CERTIFICATE OF APPROPRIATENESS

Property: 1754 North Blvd., Lot 1, Block 5, Ormond Place Subdivision. The property includes a historic 4,409 square foot two-story single-family residence and a two-story detached garage situated on a 10,500 square foot (75' x 140') corner lot.

Proposal: Alteration – *Windows, Doors, and Addition with attached garage that connects existing closed in two story historic garage and primary residence.*

Recommendation: Approval with conditions: retain existing opening dimensions for side door A1 facing Woodhead and repair exterior awning.

WEST SIDE ELEVATION – FACING WOODHEAD

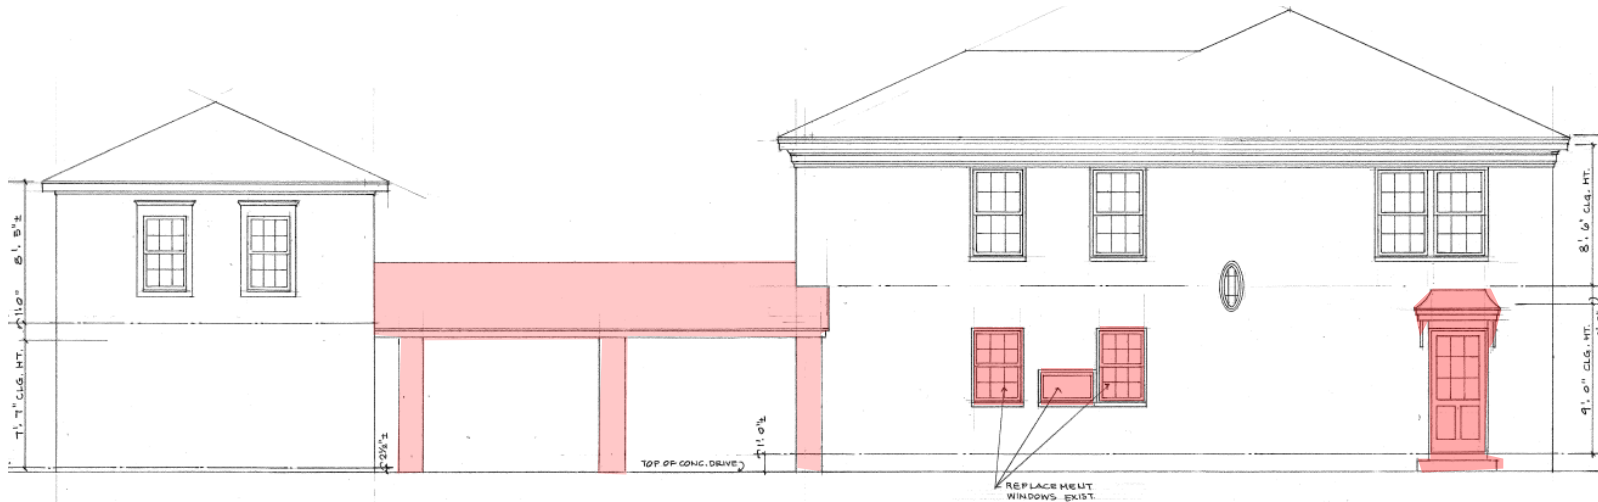
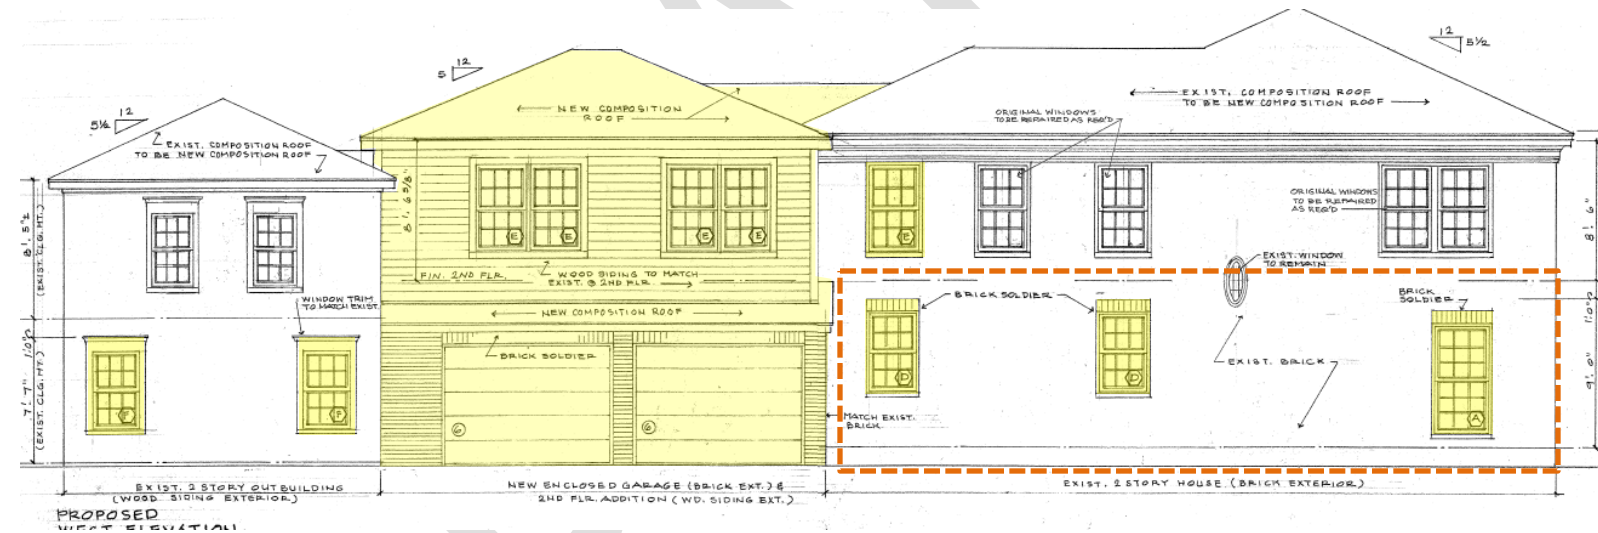
<i>If proposal retained existing door opening and awning of potentially historic side opening, this would preserve a distinguishing characteristic of the building.</i> |

<i>If the proposal retained existing side door opening dimensions, historic brickwork would not be removed.</i> |

<i>If the proposal maintained potentially historic opening and doors, historical material would not be destroyed.</i> |

Should altered windows have matching course differentiation as the historic front façade?

WINDOW PROPOSAL- alter existing door opening, replace with window to match front facade

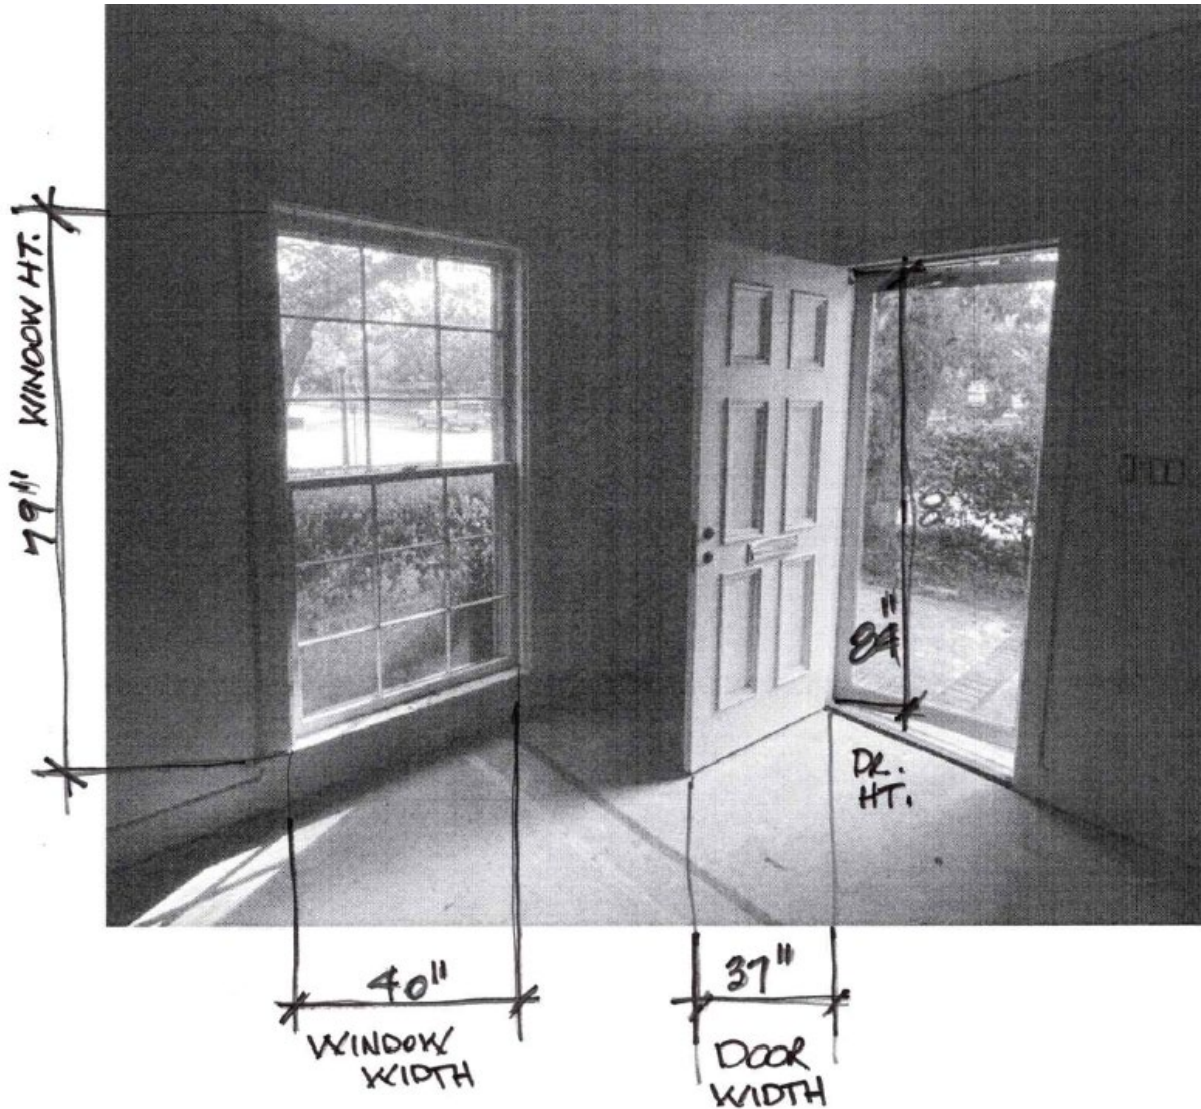
A1 – EXISTING: Non-original door on west elevation facing Woodhead Street. Likely added during 1977 renovation. Brick course above door does not match brick coursework above original windows. Door is 1.33 inches thick.

Top of existing side door entryway, may have been window

A1 – REPLACEMENT: To be replaced with new wood window made to match the original wood windows found on the front façade. The vendor is Kolbe. Specs can be found in attached PDF and dimensions can be found on the window worksheet and window schedule.
